CALL NO. 206  
CONTRACT ID NO. 121354  
ADDENDUM # 2

Subject: Trigg-Marshall Counties, 121GR12D054-BRO  
Letting November 16, 2012

- (1) Revised - Plan Sheets - R1, R2A, R2B, R7, R8, R13, R14, R31, R32, R33, R35, R36, R38, R40, R41, R83, R85, X14, X15, X16, X18, X20, X21, & X26
- (2) Deleted - Plan Sheets - R25, R26, & R86 through R90
- (3) Revised - Front Page of Proposal
- (4) Revised - Completion Date - Page 4 of 177
- (5) Added - Dynamic Pile Testing - Pages 78(a)-78(c) of 177
- (6) Added - Static & Pseudo-Static Pile Testing - Page 96(a) of 177
- (7) Revised - Material Summary - Pages 130-132(a) of 177
- (8) Revised - Bid Items - Pages 173-175 of 177

BRO 0801 (093)  
RECONSTRUCT US 68 / KY 80  
GRADE & DRAIN PLANS

COUNTY OF	ITEM NO.	SHEET NO.
MARSHALL/TRIGG	1-180.75	X18

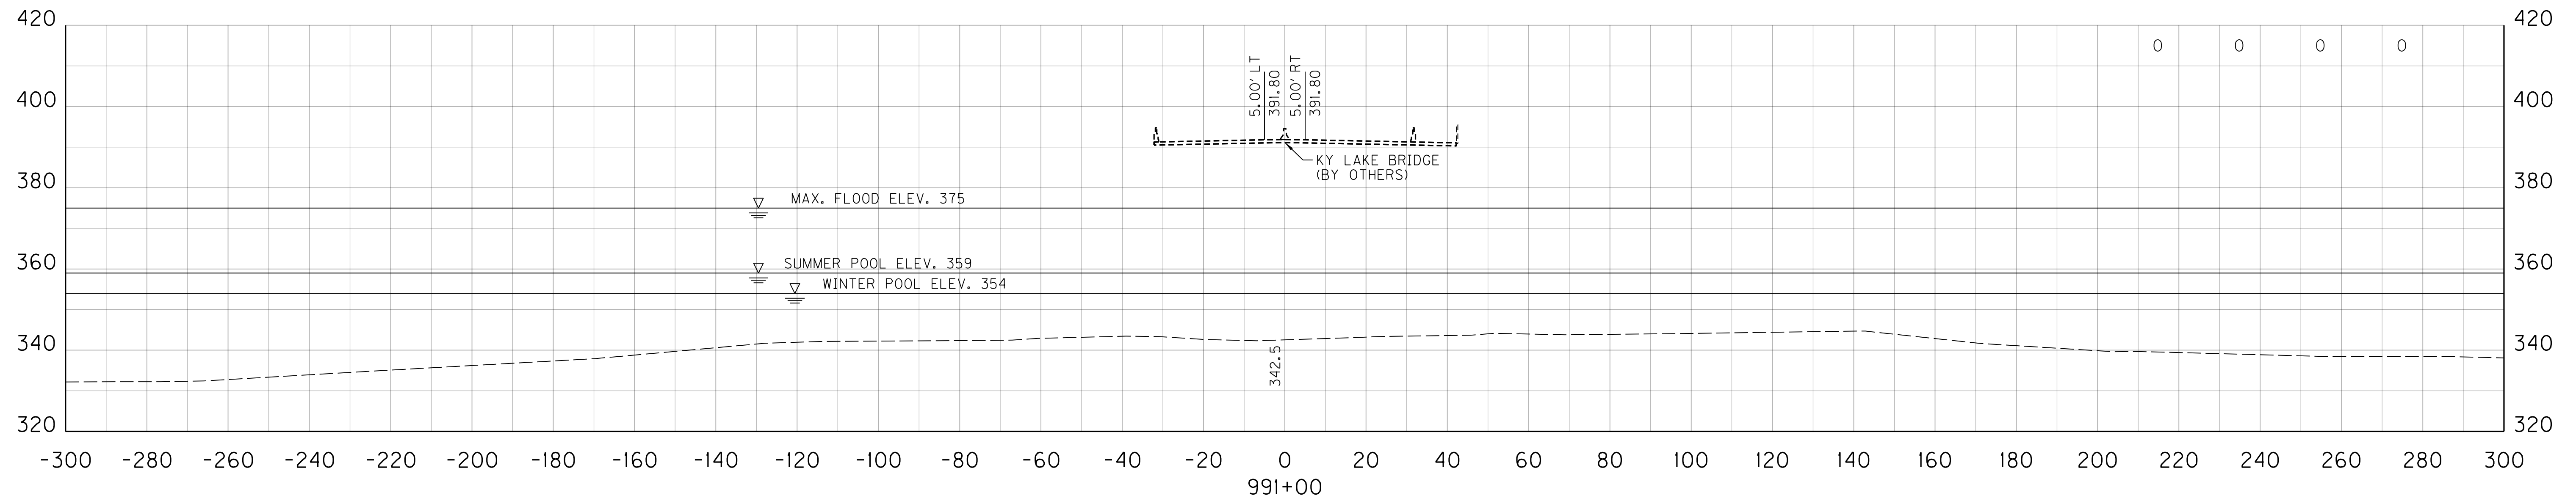
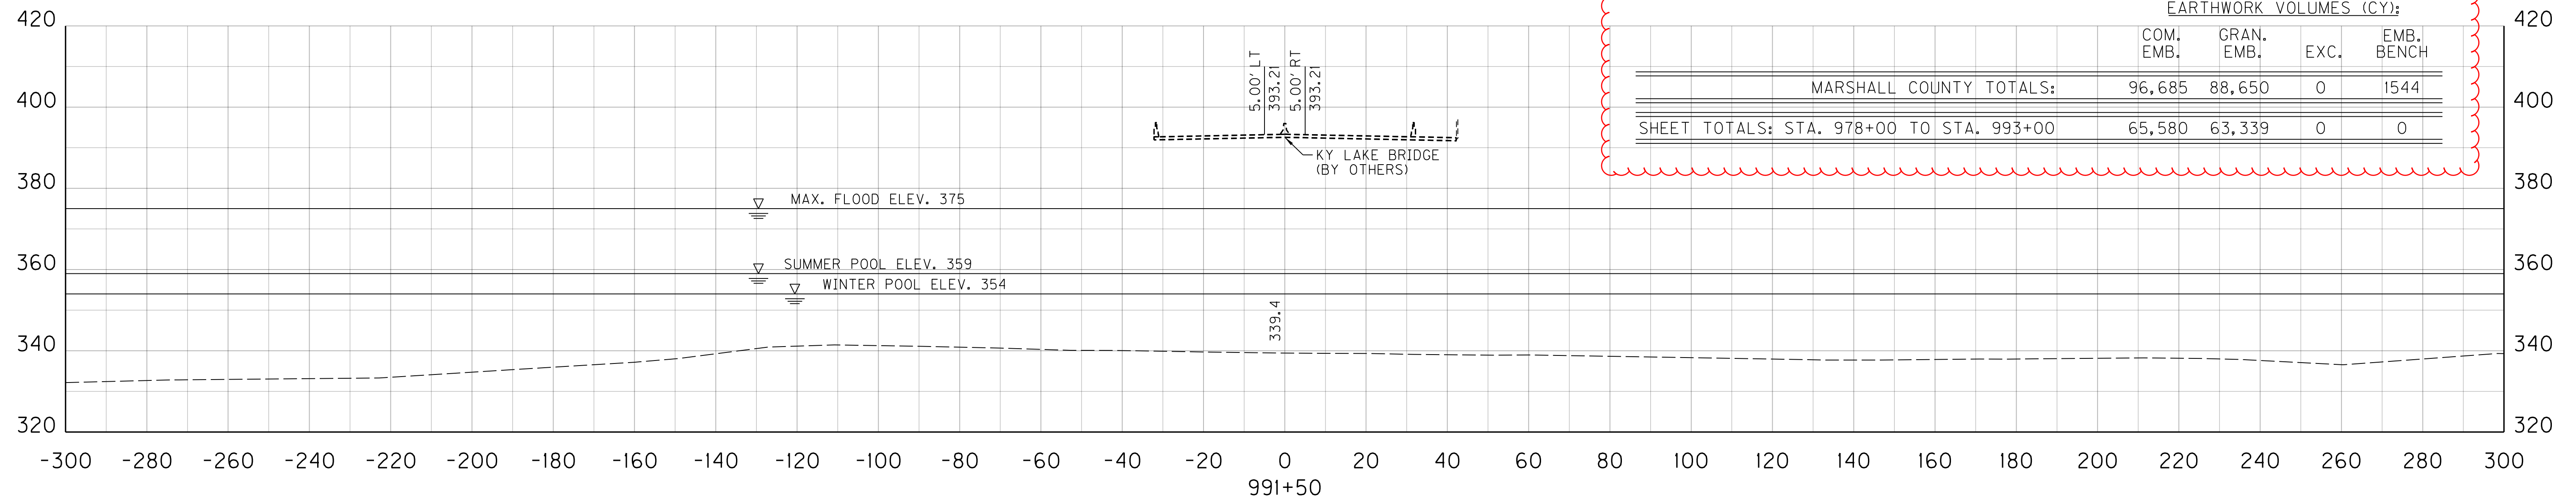
△ REVISED 10-31-12
